PUBLIC INTEREST REVIEW FOR GROUNDWATER APPLICATIONS

TO: Water Rights Section Date August 24, 2015
 FROM: Groundwater Section Aurora C. Bouchier/Ivan Gall
Reviewer's Name
 SUBJECT: Application G- 18076 Supersedes review of August 12 & 21, 2015
Date of Review(s)

A. GENERAL INFORMATION: Applicant's Name: Meza County: Clackamas

Water-Level Trends in Nearby Wells

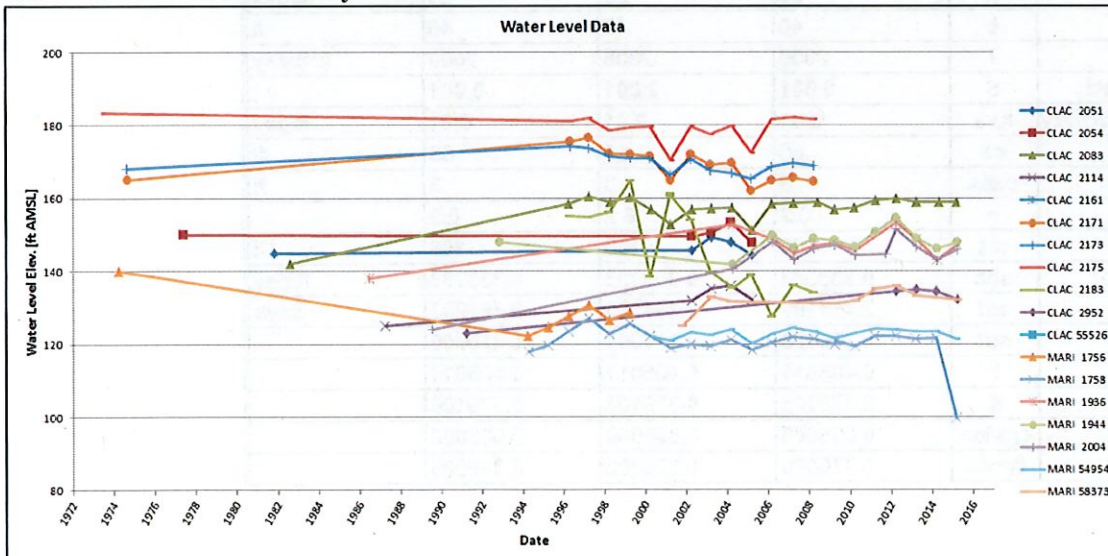
Observation from nearby wells indicate relatively stable long-term trends for alluvial wells in the immediate vicinity of the proposed POA (see attached hydrograph), but increased groundwater development in the area indicates a need for additional water-level monitoring (7N) if this permit is issued. According to the Water Master Joel Plahn (personal communication, 8/12/2015) both Butte Creek and the Pudding River (which Butte Creek is tributary to), are currently regulated. Any additional withdrawals from the streams would be undesirable.

Stream Depletion Results

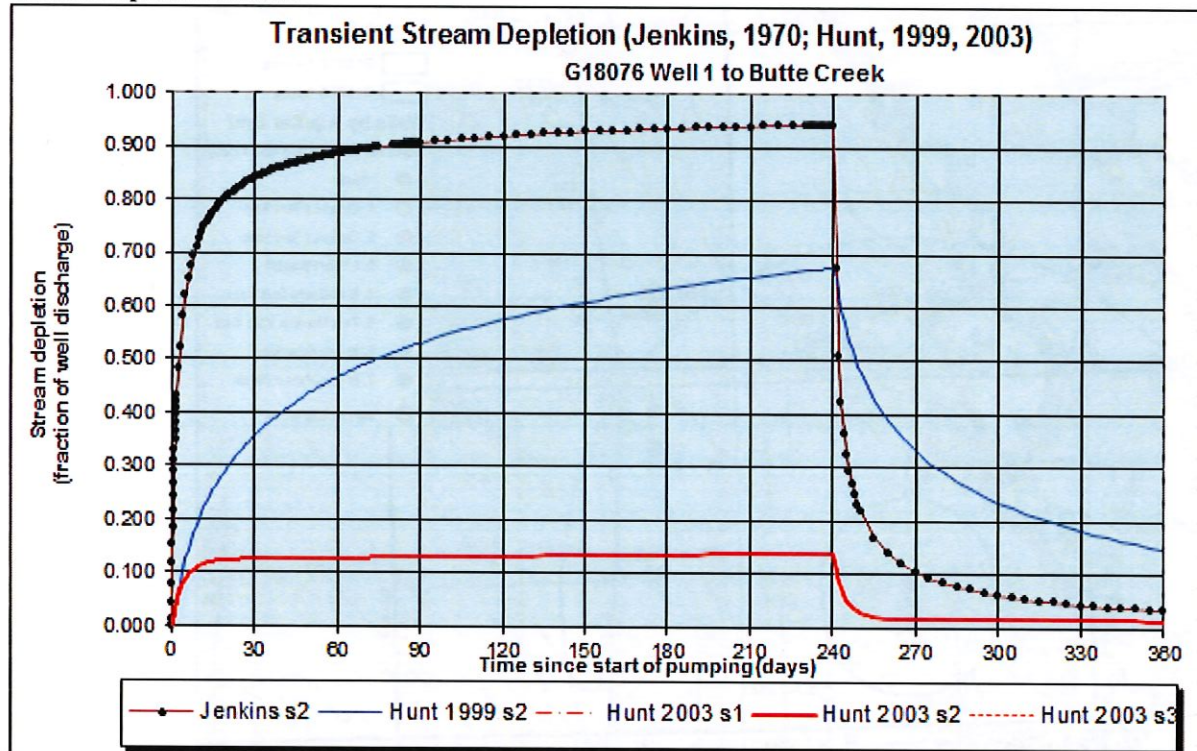
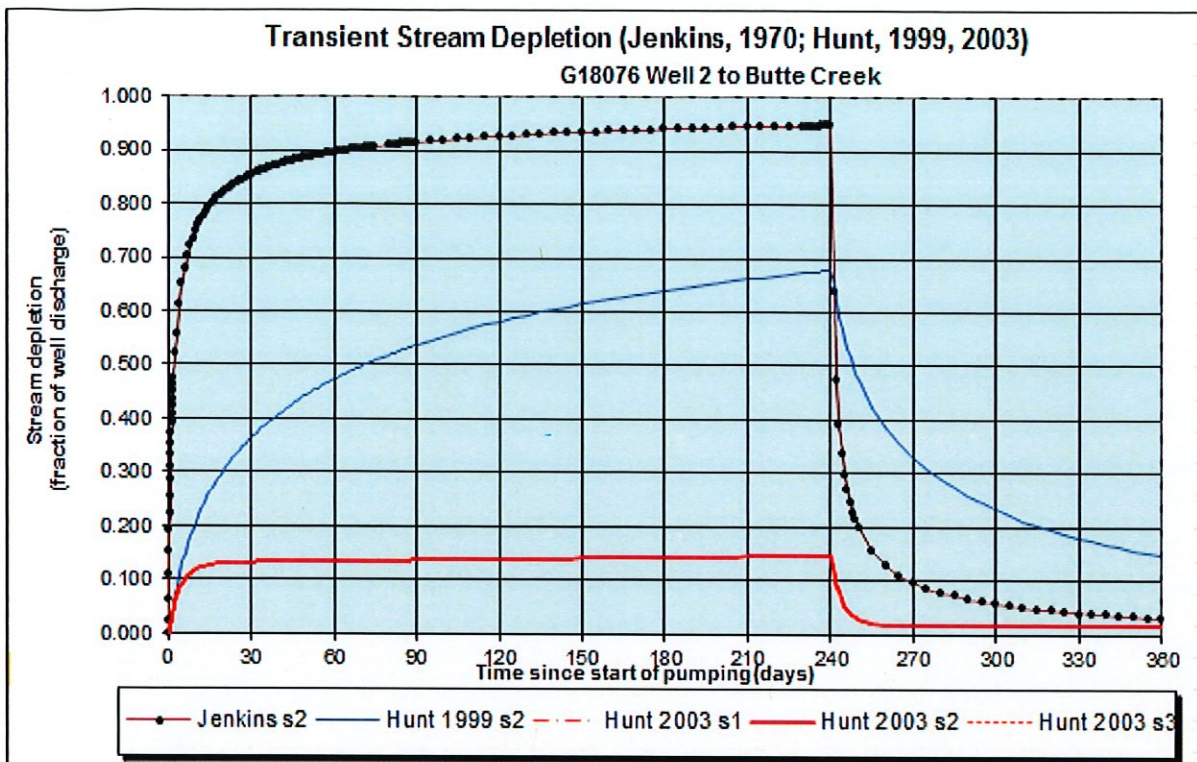
Comments: Stream depletion was estimated using the Hunt 2003 model (see attached results). An aquifer saturated thickness value of 40 feet was used based upon published maps (Gannet and Caldwell, 1998). Butte Creek cuts through the Willamette Silt in this region. Therefore, stream clogging was modeled by using an aquitard thickness below stream value of 3 feet.
